PROPOSED TEMPORARY BRIDGE
RIVER BETWEEN TWO MOUNTAINS
PROTECTION MILE 411.6
MACKENZIE HIGHWAY, N.W.T.

MEMORANDUM

MACKENZIE HIGHWAY, PROPOSED TEMPORARY BRIDGE,
RIVER BETWEEN TWO MOUNTAINS

HYDROLOGIC ASSESSMENT AT SITE OF PROPOSED TEMPORARY CROSSING

FIGURE 1

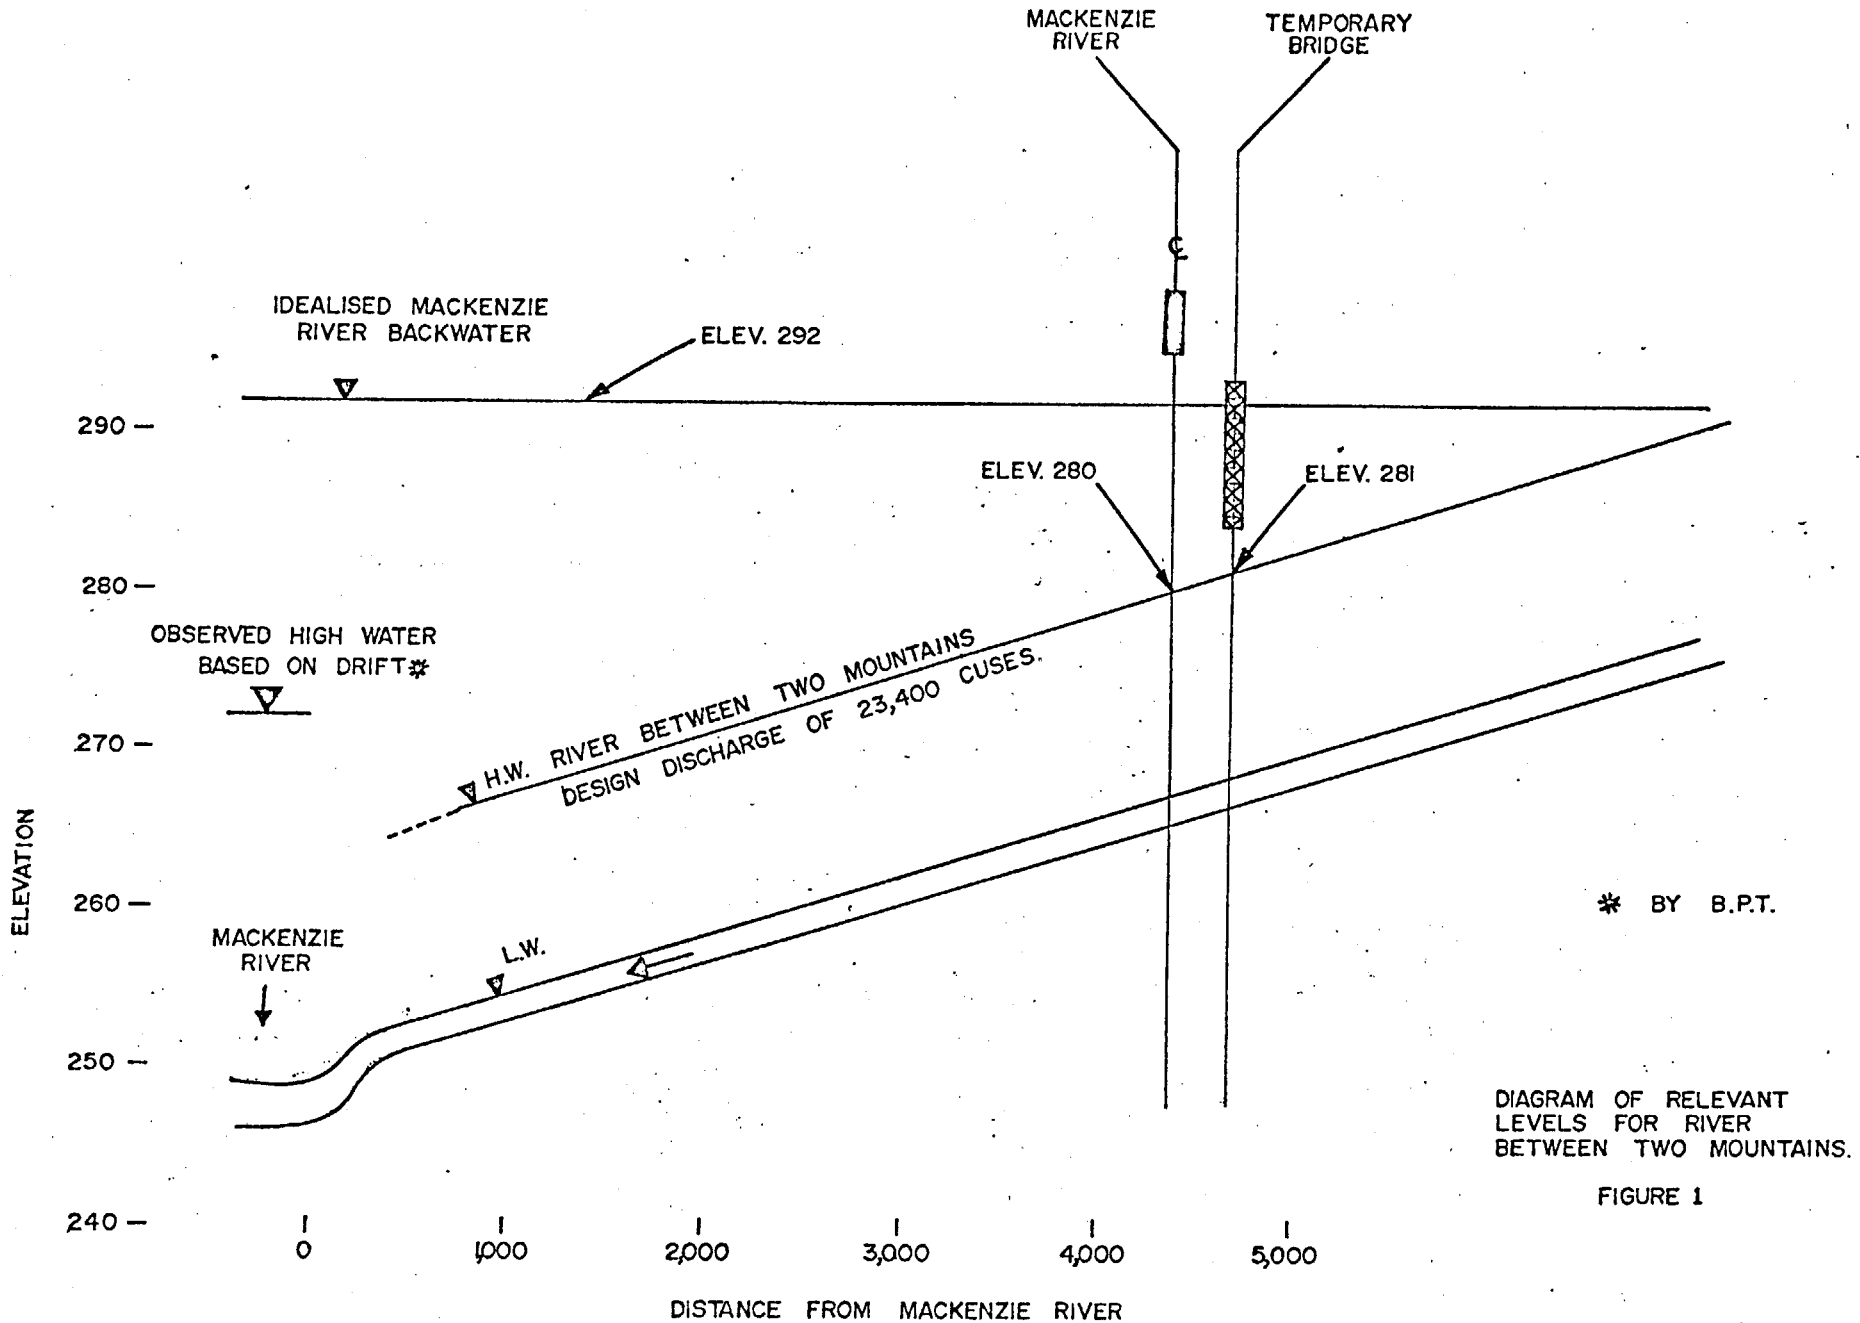
The Bailey Bridge type structure will be set to allow 3 feet clearance to the underside from the estimated high water level of elevation 281 of the River Between Two Mountains at design flood. The approach grades are lower than the bridge deck and would be overtopped during flood stage although the bridge itself would not be affected.

The effect of an ice-jam on the Mackenzie River would possibly cause back up water to an elevation of 292 at the bridge site.

Figure 1 shows the relevant locations and water levels.

CALCULATED RISK DIAGRAM AFTER HERSHFIELD AND KOHLER

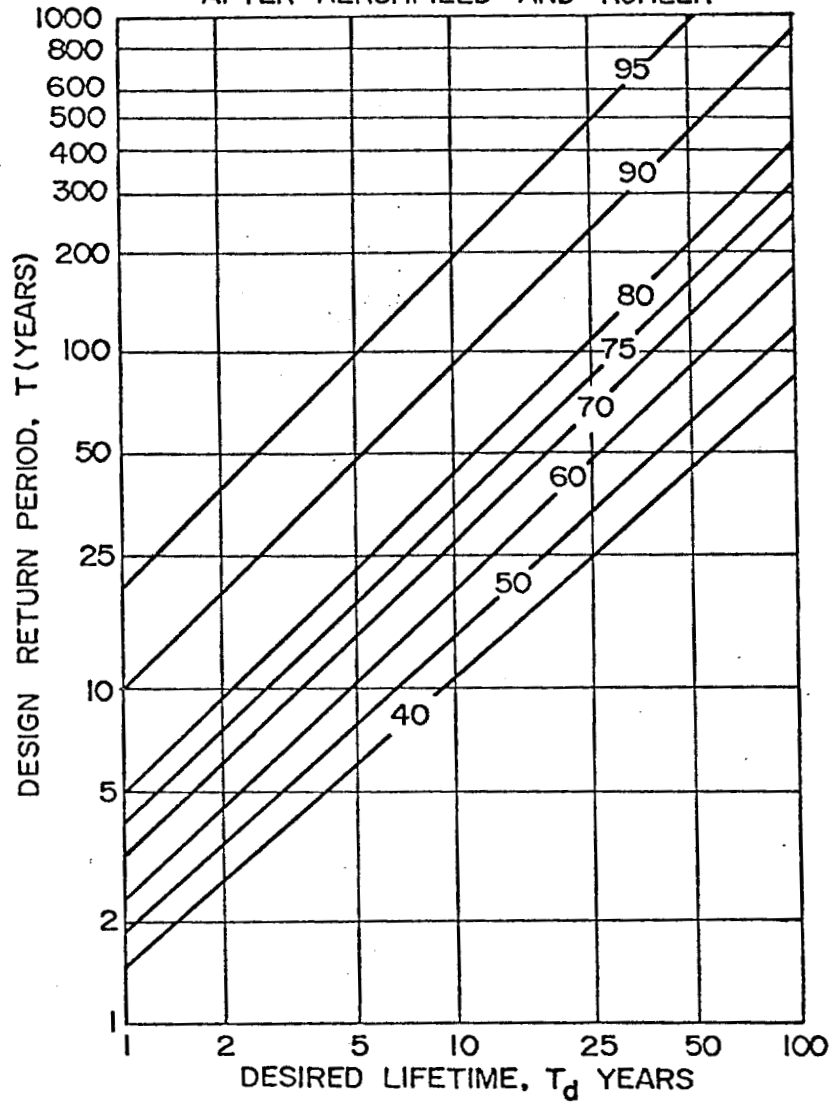
The risk factors involved for various return periods are shown in Figure 2 and by inspection, the theoretical probability of a structure not failing with a desired lifetime of 2 years and a design return period of 50 years is greater than 95%. This applies to design flood only and does not take into account the probability of ice run not occurring simultaneously with design high water.

It would appear reasonable to conclude that the risk of design flood and ice run occurring together would be in the order of 1%.
